Re: Response to Agency Comments on Soil and Water Report, The Next Generation, Energy From Waste Plant, Eastern Creek.

I have reviewed the relevant comments and have addressed those relevant to the Edison Environmental & Engineering (Edison) report entitled *Assessment of Soil and Water Impacts: Proposed Energy from Waste Facility, Eastern Creek (E15002-DADI-001)* herein.

This letter provides a response to comments from: Environment Protection Authority of New South Wales (EPA NSW with EnRisk and Arup); Blacktown City Council; and Hanson.

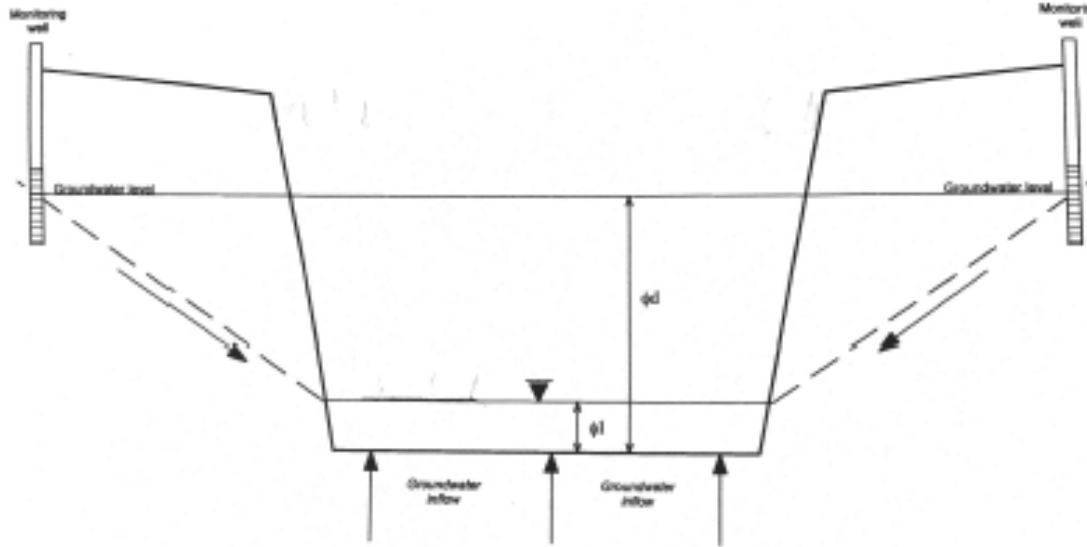
Letter	<p>Inadequate Groundwater Impact Assessment. Insufficient detail provided in the EIS on the nature of the waste bunker to adequately assess true impacts on the groundwater system that flows through to Ropes Creek and potential GDEs and IDEs.</p> <p>“The waste bunker, some 15m deep, has the potential to intercept and possibly obstruct</p>
--------	---

The volume of inflow through the base of the bunker (assuming no confinement) can be estimated using equations derived by Haitjema (1992). A schematic diagram showing the relationship of the input parameters is presented in the figure below. The following model was adopted:

$$Q = K ((\Phi d - \Phi l) / \Phi d) A$$

Total water consumption at different load points with 4 Lines running on 100% load:

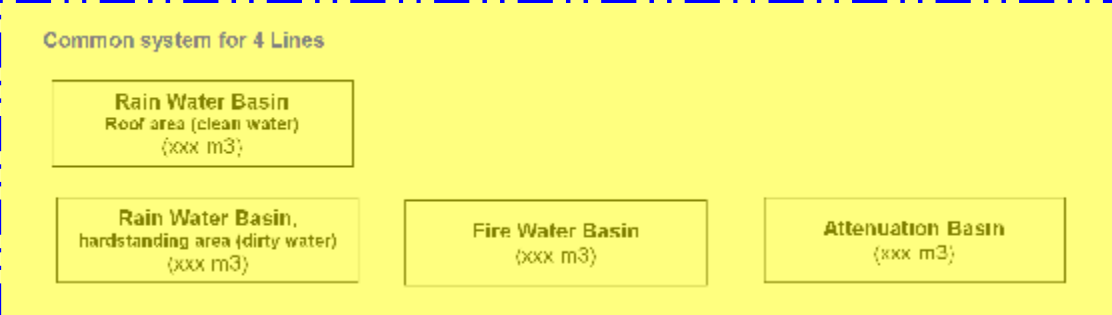
- a. The overall water consumption is nominated as 25.6 m/h (Concept Design pg 25), but no breakdown is provided. It is assumed that the water treatment plant effluent and the boiler blow down volumes will be consumed by ash quenching. Therefore the wastewater will be disposed with the bottom ash in evaporation and absorption (bottom ash 25% H₂O by weight). The wet bottom ash is proposed to be recycled as aggregate, however water may degrade the value of the aggregate.

- d. No water balance is provided, which is essential to determine how water is used and reused within the plant. The Soil and Water Report Section 7.2 and EIS Section 3.16 deal with water only at a high level for the actual power plant.

Response: The plant designer, Inova HZI has prepared a water balance for the plant (attached). The water balance provides a detailed account of water use in the plant. The water balance shows the amount of water expected to be use for ash quenching but does not estimate the water content of the quenched ash.

Response: Plant designer Inova HZI prepared the water balance for the plant (attached). The water balance provides a detailed account of water use in the plant.

Schematic Cross Section with Existing and Predicted Groundwater Pressure Surfaces

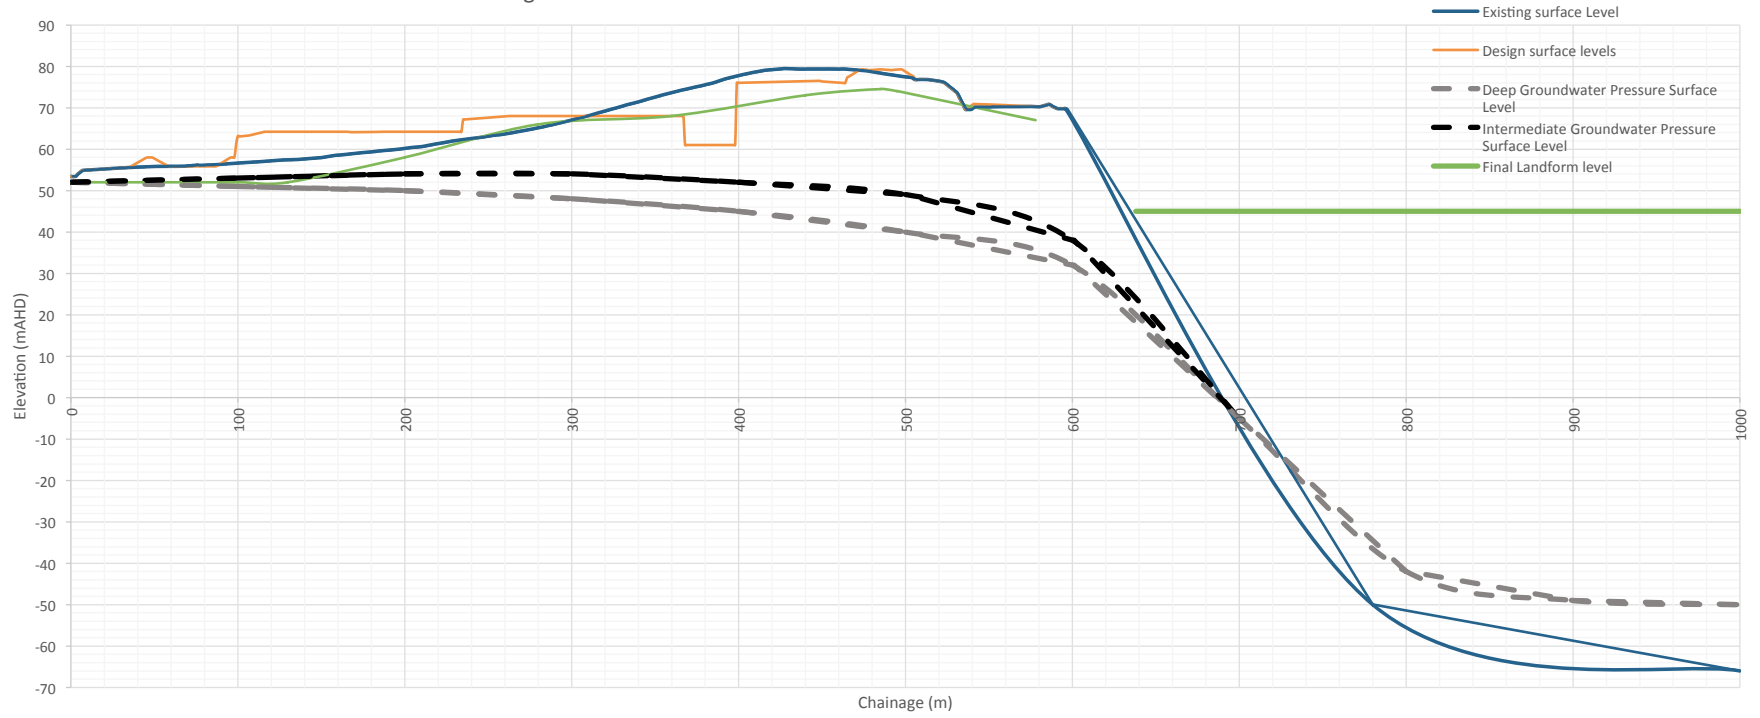
<p>shallow groundwater flow. As no significant groundwater is expected to be encountered at the proposed excavation depths, the potential impacts are considered to be negligible.”</p> <p>Figure 3.6 of this report shows the location of groundwater monitoring bores (piezometers) within the vicinity of the proposed development. Table 3.3 of this report states that the depth measured to ground water at these bores:</p> <p>It is evident that the proposed invert of the waste bunker will be significantly lower than the existing groundwater levels. There is insufficient detail provided in the EIS on the nature of the waste bunker to adequately assess true impacts on the groundwater system that flows through to Ropes Creek and potential GDEs and IDEs. According to the BOM GDE and IDE mapping (below) the area in question is highly likely to have ground water interaction and have GDEs and/or IDEs reliant on surface and subsurface ground water flows. The EIS has made no assessment of the impacts on these GDEs and IDEs.</p>

A cross section of the site showing the current and proposed land surface, intermediate and deep groundwater pressure levels and interpreted shallow groundwater table is attached. The data herein are derived from IGGC (2014). The location of the cross section is shown in the attached plan prepared by AT&L.

- The existing ground surface at the location of the proposed waste bunker ranges from ~74 to ~78m AHD;
- The level of the base of the waste bunker is ~61 mAHD;
- The interpreted shallow groundwater table at ~68-70 mAHD (IGGC, 2015);
- The completed width of the waste bunker is approximately 32 m.

It is expected that, over time, the shallow groundwater table will be depressed in the area around the waste bunker. Groundwater inflows are expected to be greatest immediately following completion of the excavation and then progressively decline as water until levels stabilise.
